**RECOMMENDATION MEETING
OF
SOUTH EAST DESIGN REVIEW BOARD**

Meeting Date: July 24, 2007
Report Date: July 31, 2007

Project Number: 3001242
Address: 1400 S. Dearborn Street
Applicant: Bill Fuller, Fuller Sears Architects for Darrell Vange, Ravenhurst
Development
Board Members present: Ann Beeman (chair)
Mona Campbell, substitute
Michelle Wang
John Woodworth
Board Member absent Robert Mohn
DPD Staff: Vincent T. Lyons, Manager, Design Review Program

RESIDENTIAL OPEN SPACE PLAN

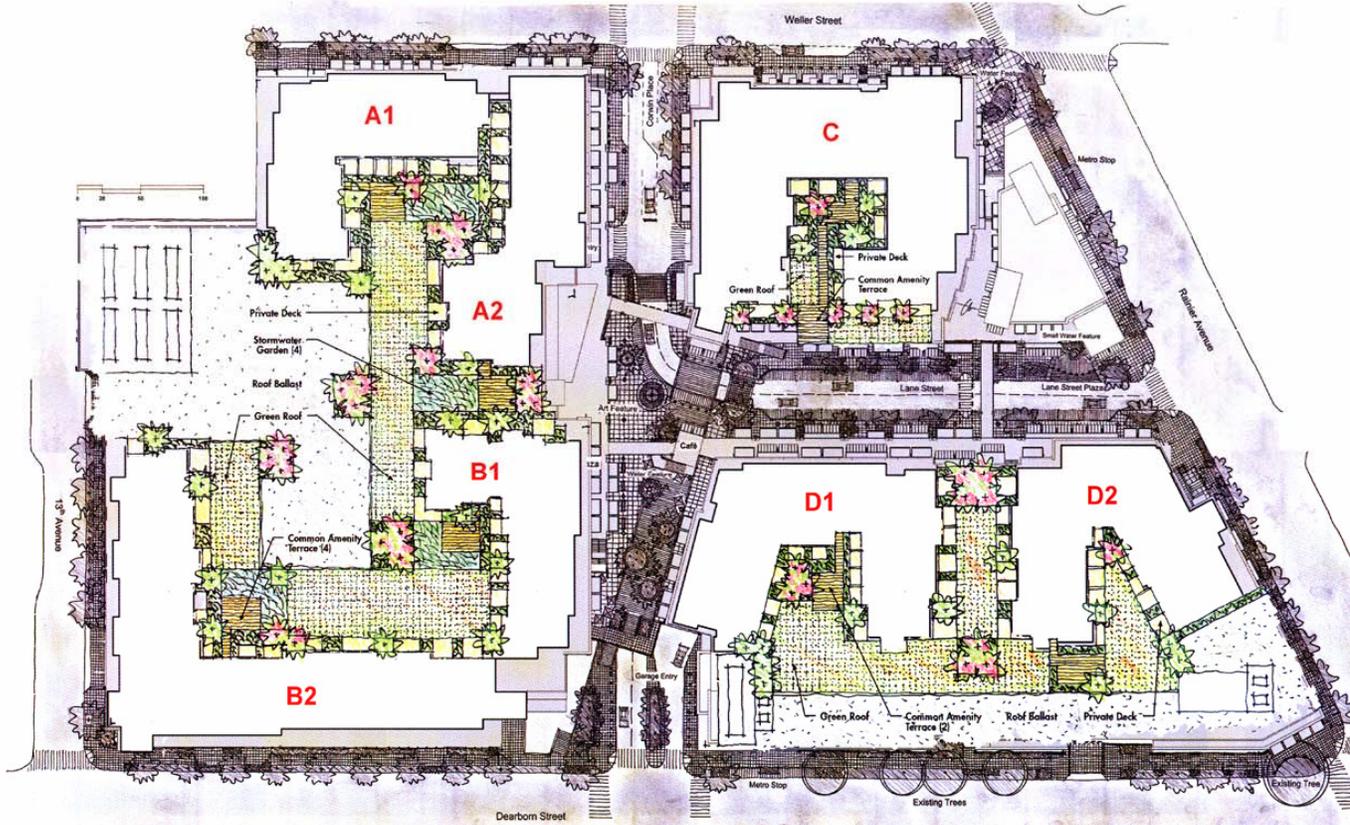
The Board appreciated the two and three dimensional graphics showing the proposed public amenity, open space and green factor designs (pp. 17-24). The board members initial discussion on these elements noted general satisfaction with the open space areas and the design’s ability to meet the green factor on site. Some concern that the lower roof above Rainier will need some high quality design work. Another member felt that the residential element should be more like the commercial base landscaping vs. running bamboo. The board likes the general size of the 60 x 80 foot “J” shaped open space (p. 17) adjacent to B1 and B2, but thinks the location on the north side of B2 will end up in shadows. This “Post Alley” spaces needs further design work.

- The Board recommends filling in the “J” with usable open space area to allow more sun and larger area for more outdoor activities such as pea patches and play equipment.

The board discussed the proposed edges between walkable surfaces, the green roofs and the common amenity spaces.

- The Board recommended that the applicant explore design techniques to make these edges softer but clear where access is allowed (not onto green roofs). Explore techniques like massing plant material along the edges and providing seating ledges that would also serve as barriers to the green roof, and other measures to create good usable and diverse outdoor areas. (A-7).
- The Board recommended creating more common lobby area spaces so that the residential entries also read well from the outside at this second level residential deck level.
- The Board recommends putting more large scale plantings in the open space areas.

RESIDENTIAL LOBBIES AND ELEVATORS

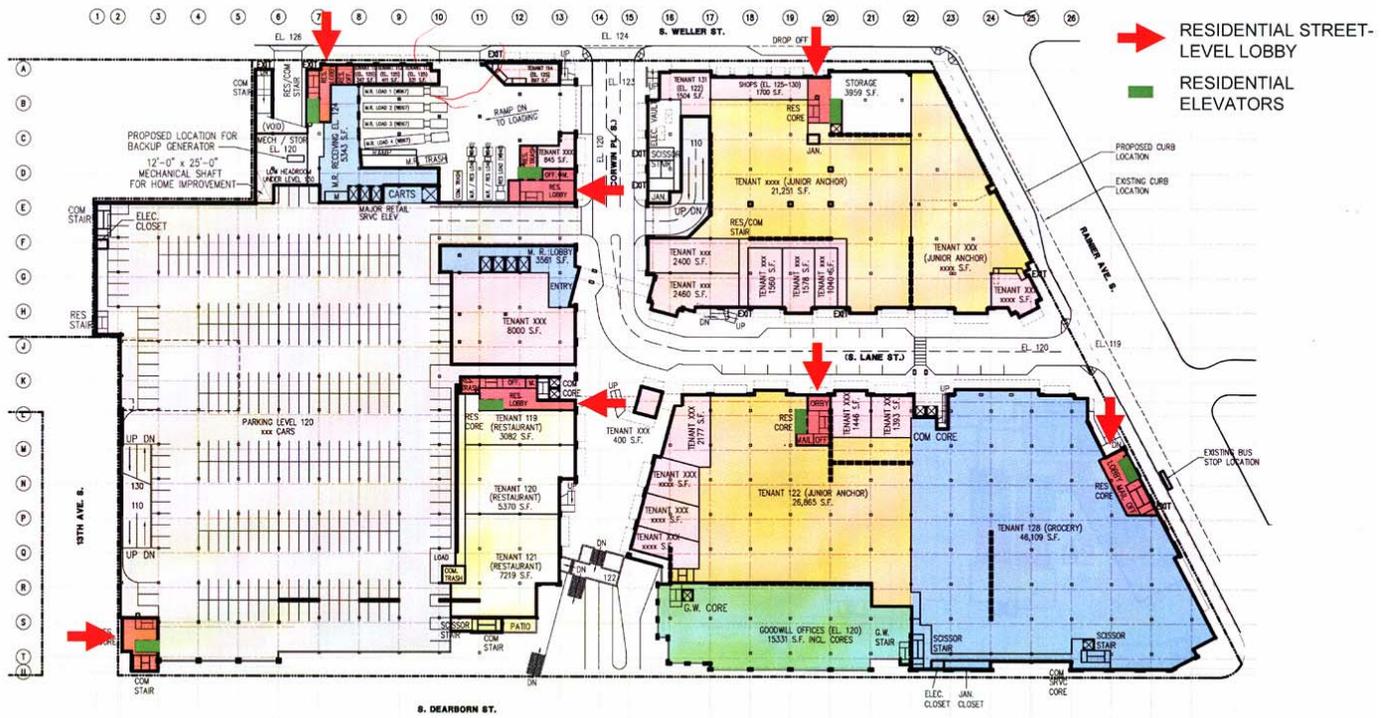
The Board feels that the design of the residential entries to date seems to be a 2nd priority and need to be more studied.

- The Board discussed the residential entry designs and recommended that the weathered copper material should be brought down to the street level for all residential entries as shown on the Dearborn elevations. (A-2, A-5) The residential entry design on Weller should be changed to reflect this recommendation.
